Application for Licence Amendment

Licence Number	L8008/2004/3
Licence Holder	FQM Australia Nickel Pty Ltd
ACN	135 761 465
File Number	DER2014/000631-1~7
Premises	Ravensthorpe Nickel Operations Legal description – Part of Mining Tenements M74/175, M74/115 and M74/116 JERDACUTTUP WA 6346 As defined by the Premises maps attached to the Revised Licence
Date of Report	22 August 2023
Decision	Licence granted

Figure 4: Magnesium and Sulphate (combined total concentration) Predicted Plume Concentration (g/L) for Scenario 2, 2029.

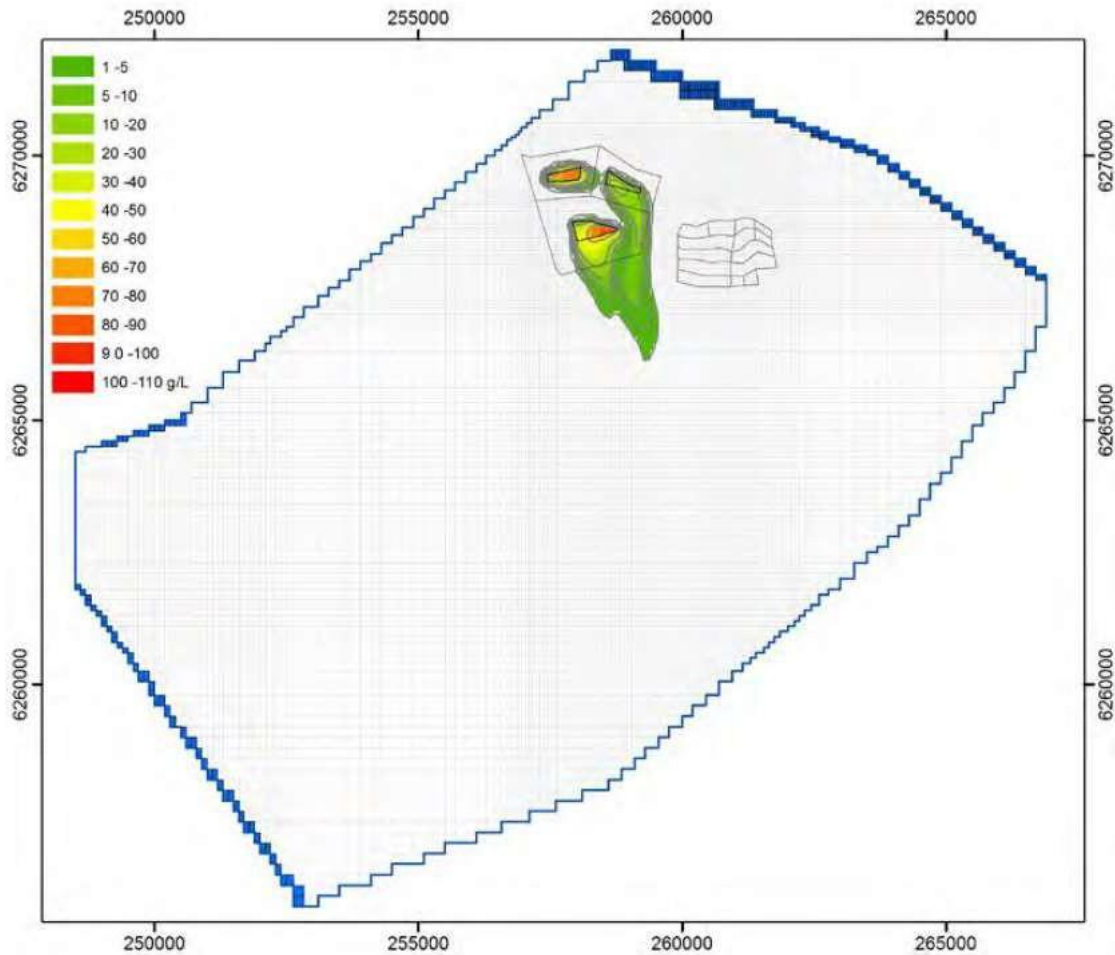
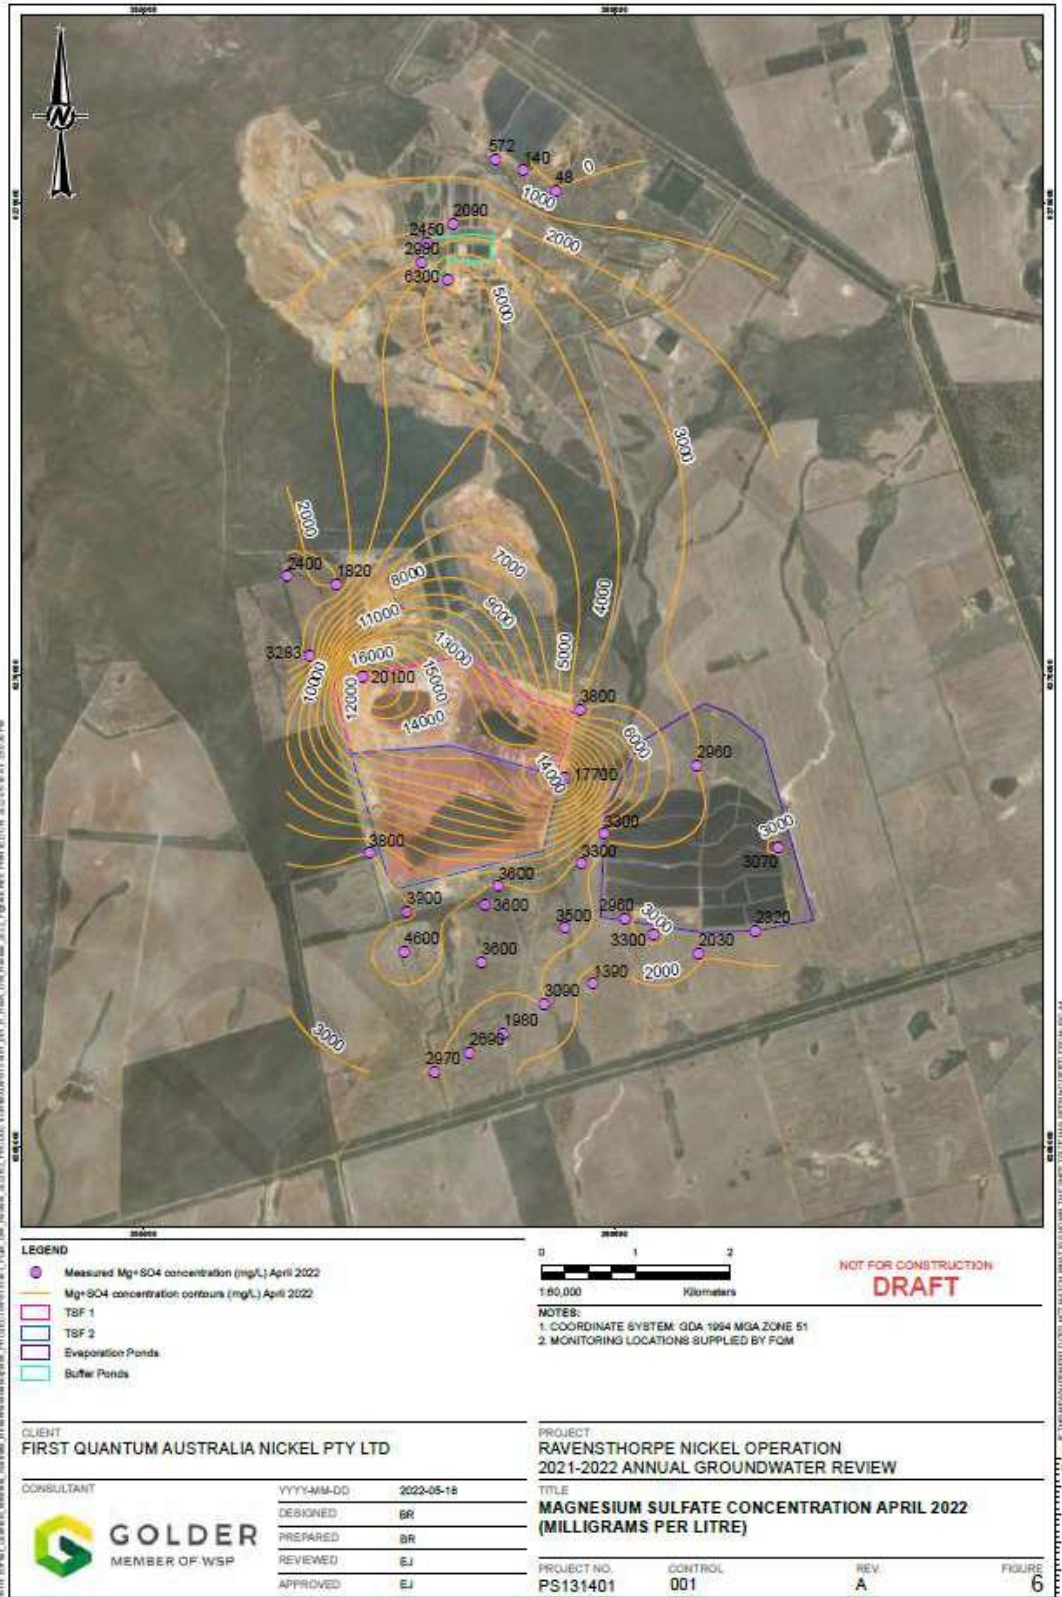
The “likely case” seepage prediction suggested that the magnesium and sulphate plume in Figure 4 would migrate south. Monitoring undertaken in 2022 confirms that the plume is migrating south. Figure 6 shows magnesium sulphate levels recorded in the southern monitoring wells. DWER notes a drop in magnesium sulfate levels during the period the premises was in care and maintenance.
